SUBJECT: **Public Hearing for Final Site Plan & Special Land Use Permit Amendment at 203 Pierce – Toast Birmingham**

TOAST RESTAURANT
203 PIERCE
SPECIAL LAND USE PERMIT AMENDMENT
2015

SUBJECT: **Report for Final Site Plan & Special Land Use Permit Amendment 203 Pierce – Toast Birmingham**

Proposed Outdoor Dining Platform

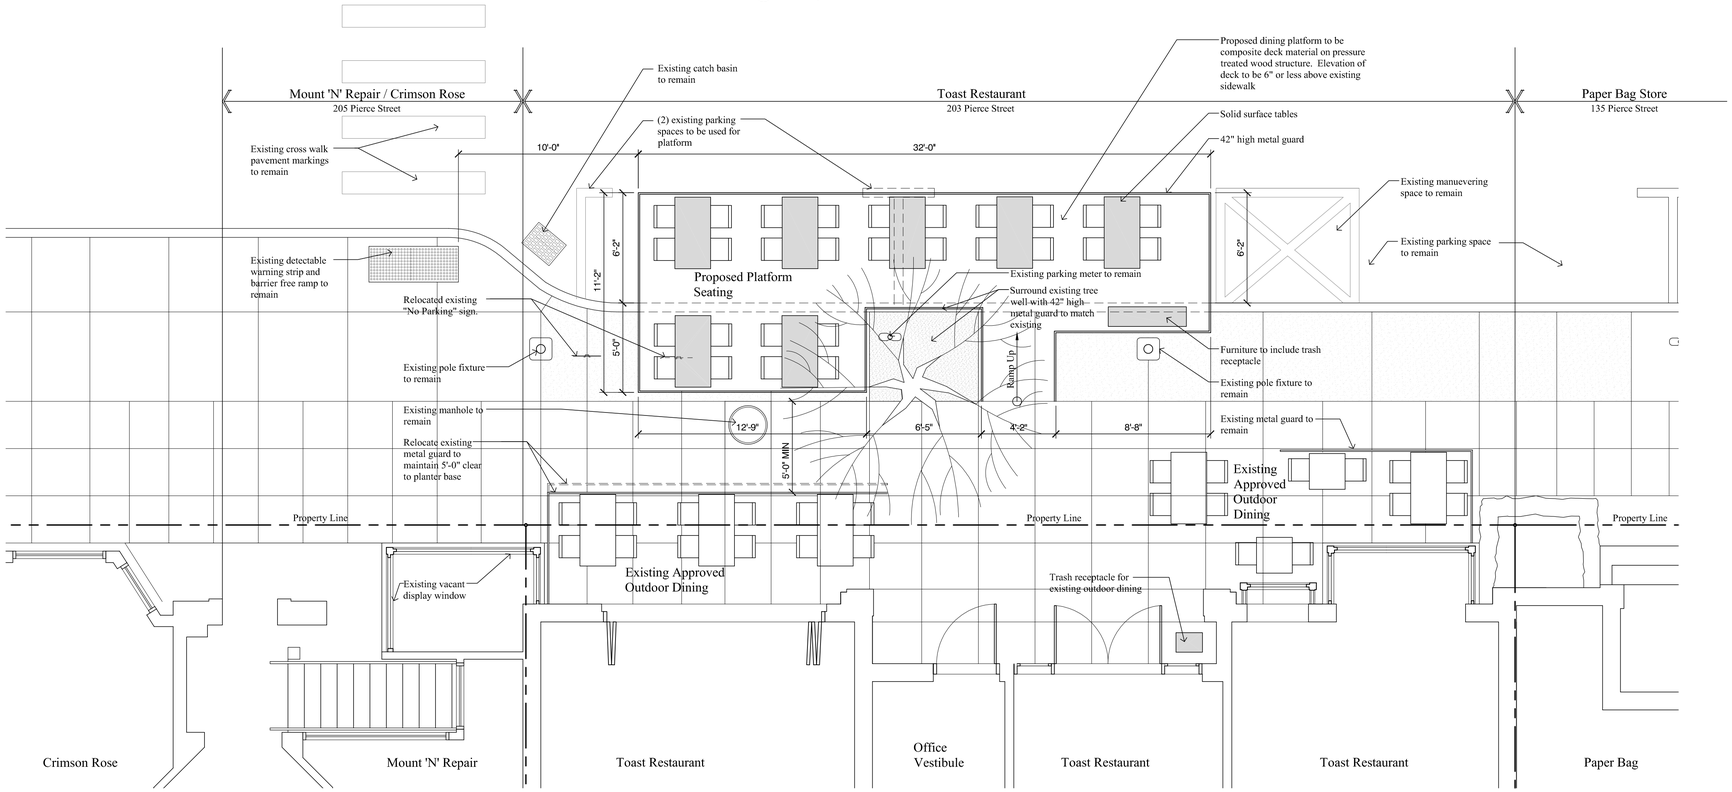
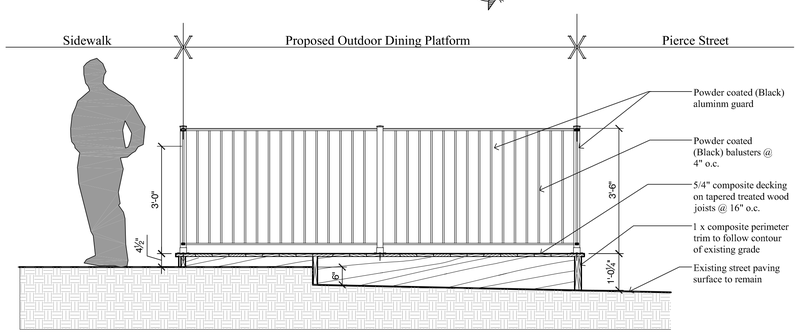
4.4 Pedestrian Access & Circulation – Pedestrian access to the outdoor café is available directly from the City sidewalk. Under the 2016 Plan, outdoor cafes are encouraged as they create a more pedestrian friendly environment. All outdoor dining areas must maintain a 5 foot minimum width of unobstructed pedestrian access along the storefront in the public right-of-way, however as mentioned above, the Planning Board has determined that each applicant would be reviewed on a case by case basis to determine the existing pedestrian traffic flow. The proposed layout does provide for outdoor seating along the storefront, as well as on a platform extending into two parking spaces along Pierce as recommended in the 2016 Plan. **The required 5' pedestrian path has been provided along the sidewalk except in the area of the existing tree well. The applicant will be required to provide the required 5' walk by removing tables or adding an ADA compliant tree grate to the tree well.**

1. Need a detail of the proposed guardrail to review.
2. Handrails required on the ramp

The applicant is proposing to add a new outdoor dining platform in front of the building, along Pierce Street, in addition to the existing sidewalk dining area along the face of the building. Both outdoor dining areas are proposed to be enclosed with 3' powder coated aluminum railings painted black. **A 5' pedestrian pathway, which is required, has been provided along the sidewalk except in the area of the existing tree well. The applicant will be required to provide the required 5' walk by removing tables or adding an ADA compliant tree grate to the tree well.**

The applicant has not provided any trash receptacles within the outdoor dining areas as required by Article 04, section 4.42 OD-01 of the Zoning Ordinance. The applicant intends to have business hours of 7 a.m. to 11:00 p.m. for the outdoor dining areas Monday through Saturday, and to close the outdoor dining at 4:00pm on Sundays. The proposed outdoor cafés are not immediately adjacent to any single-family zoned property.

The outdoor dining area as proposed does not provide for safe and efficient pedestrian flow as a continuous 5' wide pathway is not proposed between the platform and the seating located against the building. The 2016 Plan recommends that this pedestrian way be immediately adjacent to the storefront to allow pedestrians to see into the storefront and to have a consistent and unobstructed walkway. However, the Planning Board has discussed where the location of the

(1) The applicant provide the required 5' walk by removing tables or adding an ADA compliant tree grate to the tree well;
(2) The applicant add trash receptacles to both outdoor dining areas;
(3) The applicant provide appropriate details on the platform guardrail and handrails on the ramp to the platform to ensure compliance with the requirements of the Building Division;
(4) The applicant pay for the removal and re-installment of the parking meter where the outdoor dining platform is located;
(5) The applicant execute a revised contract with the City and obtain an outdoor dining permit.
